STATE OF HAWAII DEPARTMENT OF TRANSPORTATION HIGHWAYS DIVISION

ADDENDUM NO. 3

INTERSTATE ROUTE H-1 ADDITION AND MODIFICATION OF FREEWAY ACCESS (KAPOLEI INTERCHANGE COMPLEX), PHASE 3

FEDERAL-AID PROJECT NO. NH-H1-1(271)

FED. ROAD DIST. NO. FED. AID PROJ. NO. FISCAL YEAR 2022 ADD. 29 S-1 NH-H1-1(271)

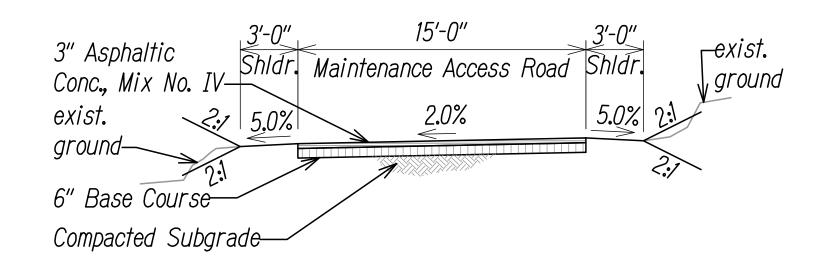
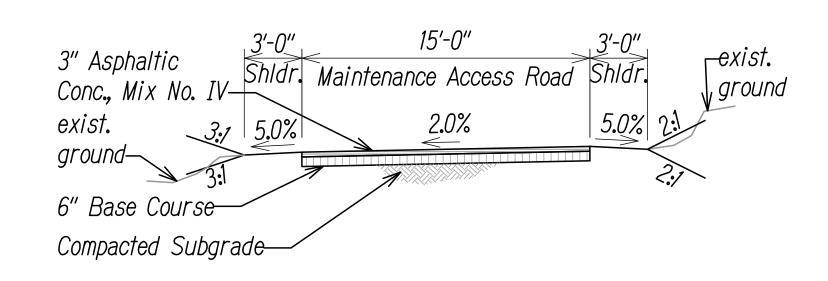
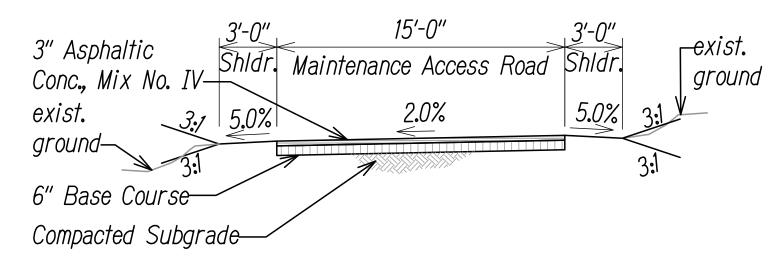
11/17/2022 | Added Maintenance Access Road

DEPARTMENT OF TRANSPORTATION HIGHWAYS DIVISION MAINTENANCE ACCESS ROAD **PROFILE**

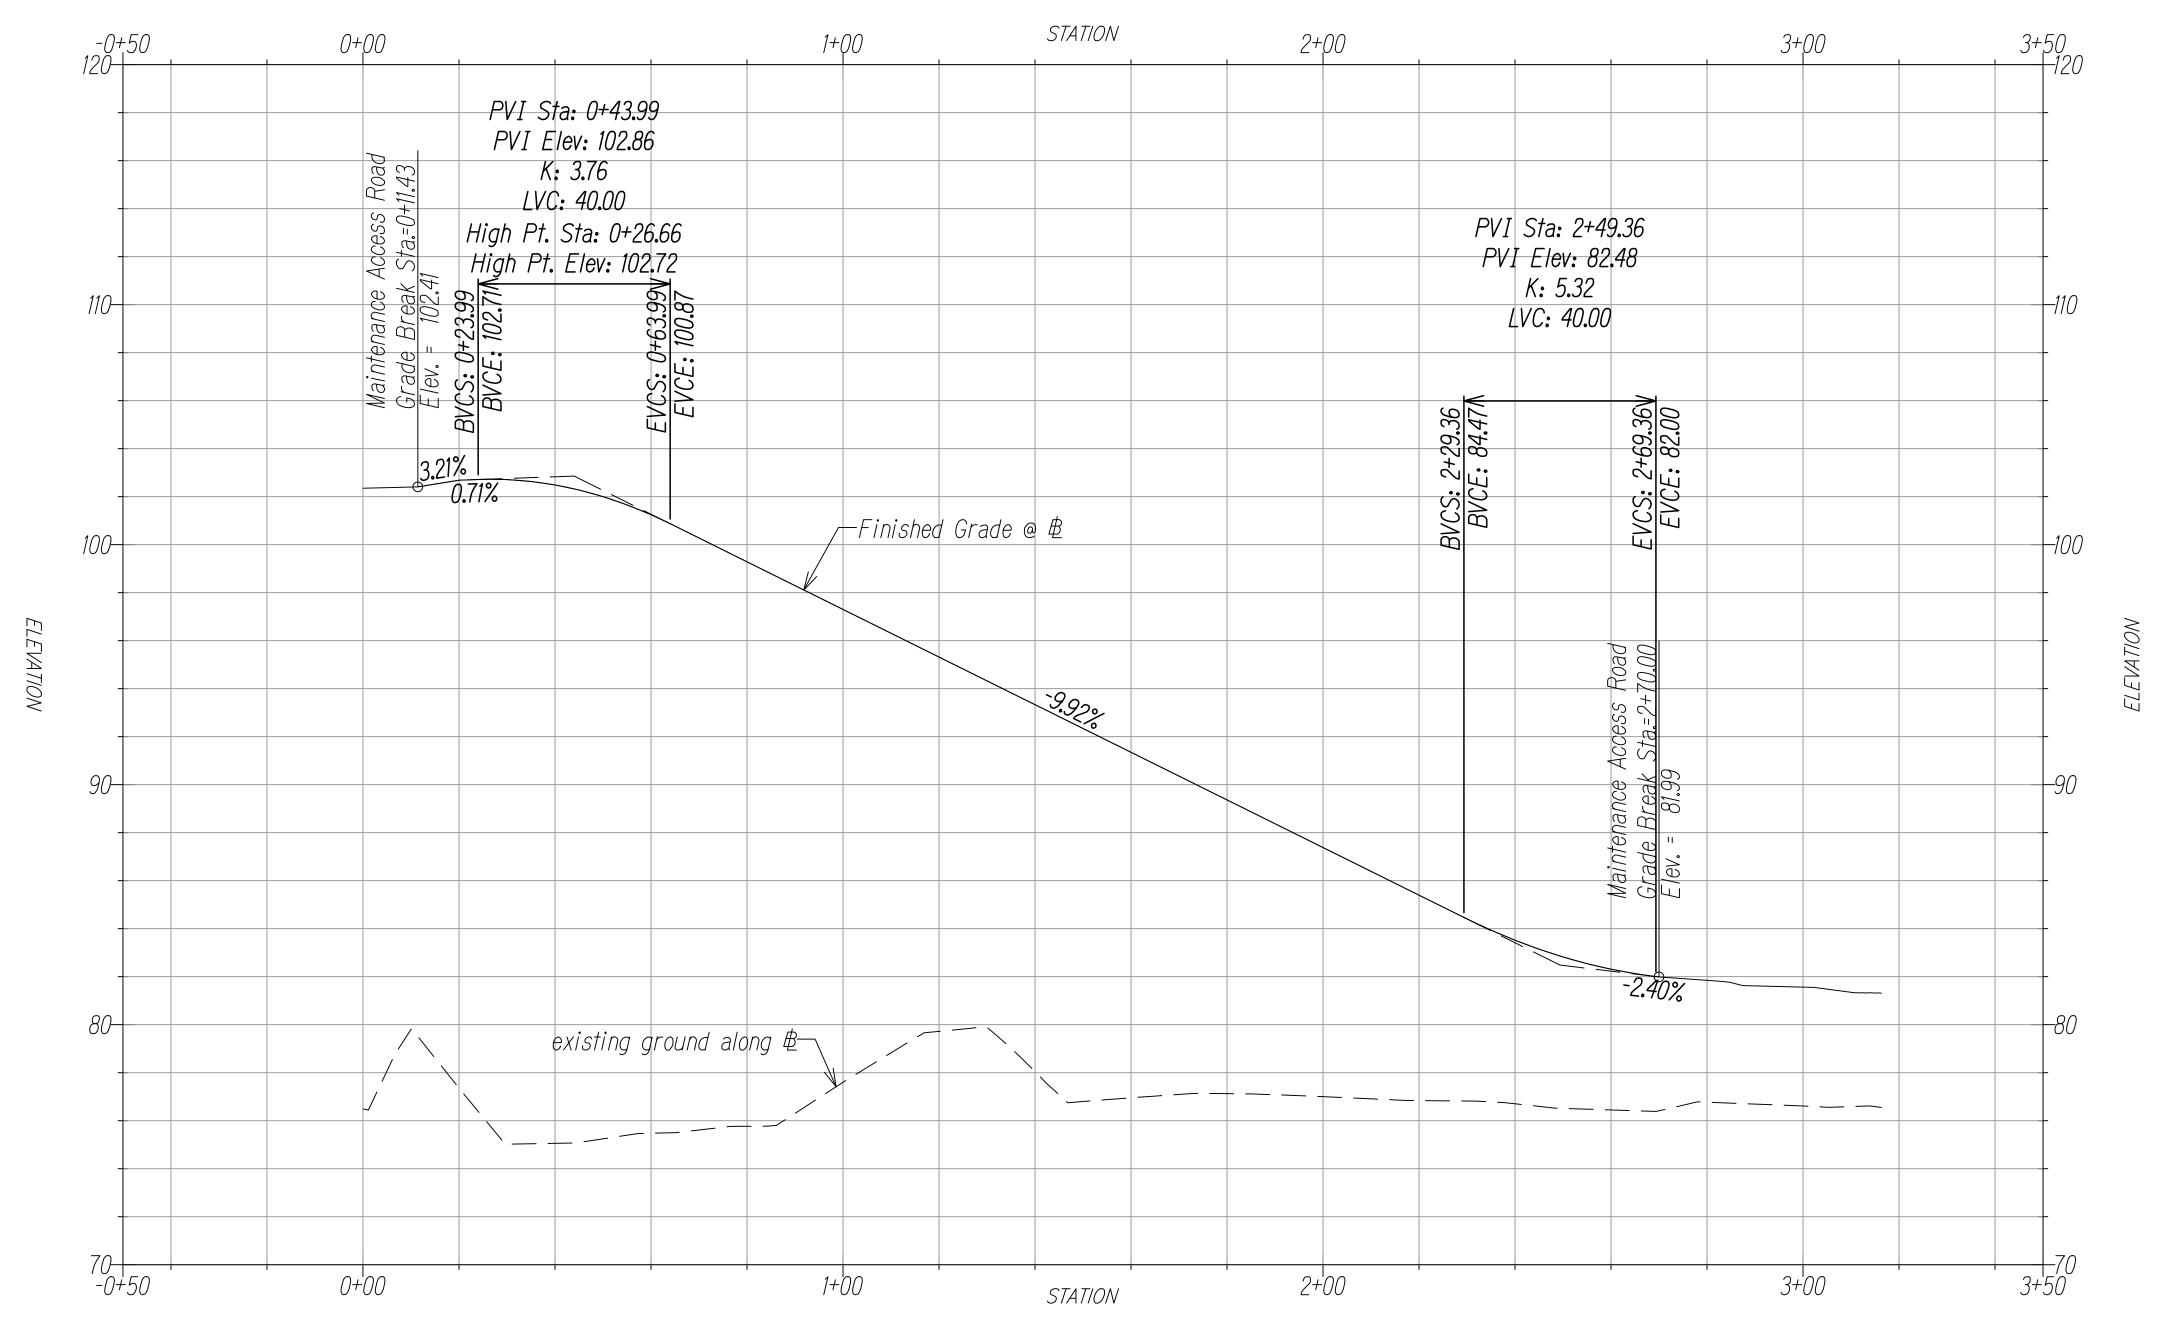
11/17/2022 Added Maintenance Access Road

DRAINAGE PLAN 2

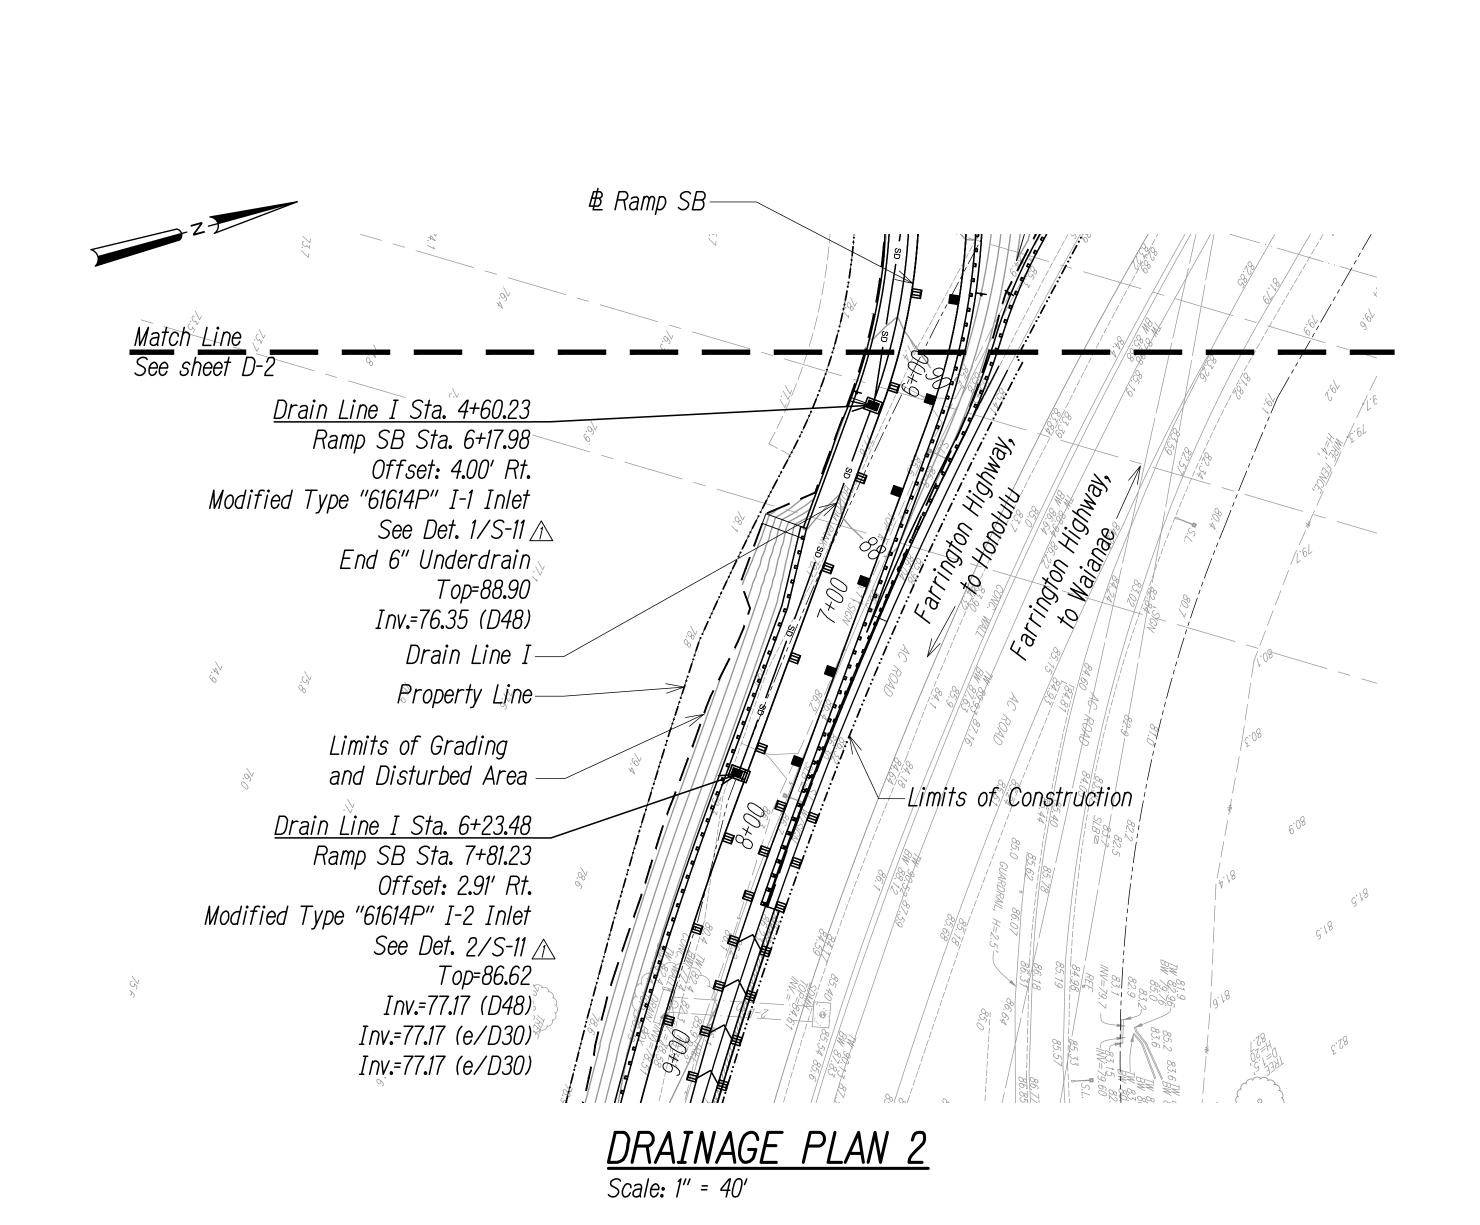
11/17/2022 Revised detail reference sheet

DRAIN LINE F PROFILE

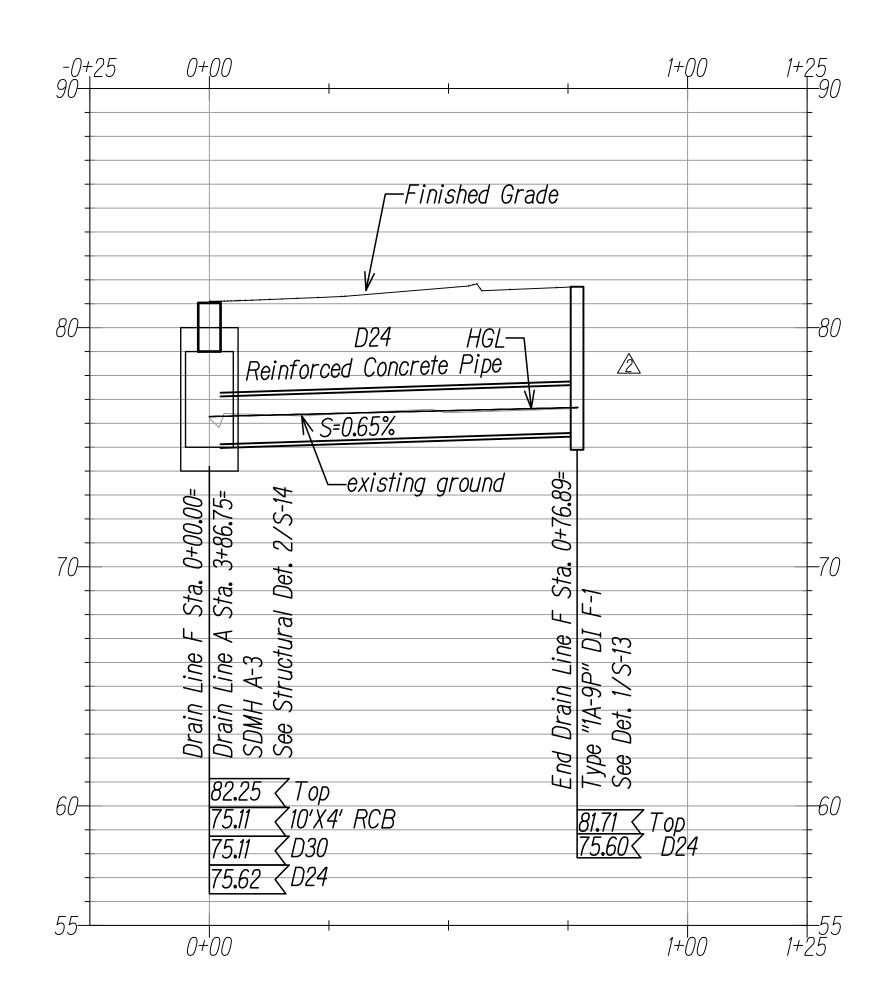
△ 11/17/2022 | Revised DL F

DRAIN LINE G PROFILE

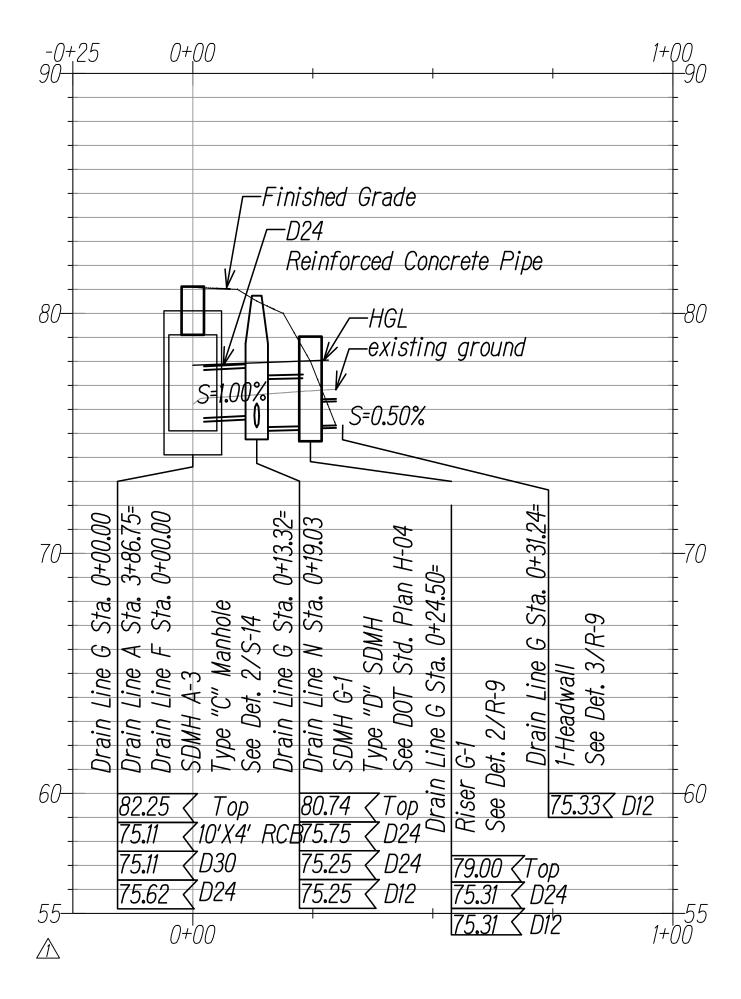
Revised DL G, revised pipe

OVERALL TRAFFIC CONTROL PLAN <u>INTERSTATE ROUTE H-1</u> ADDITION AND MODIFICATION OF FREEWAY ACCESS

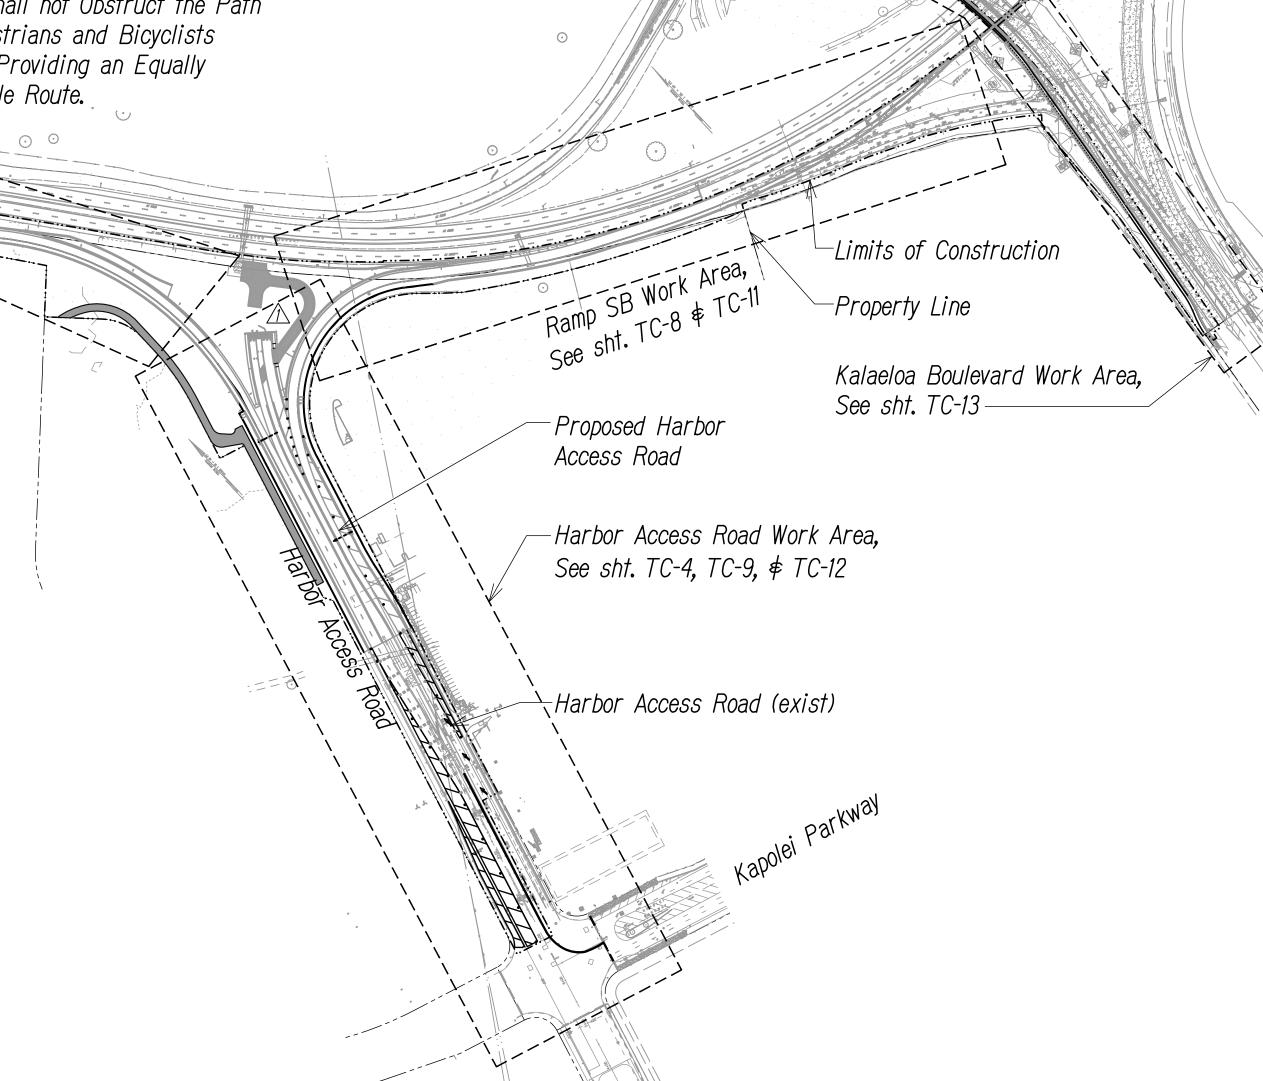
11/17/2022 | Added Maintenance Access Road **ENGINEER** No. 12144-
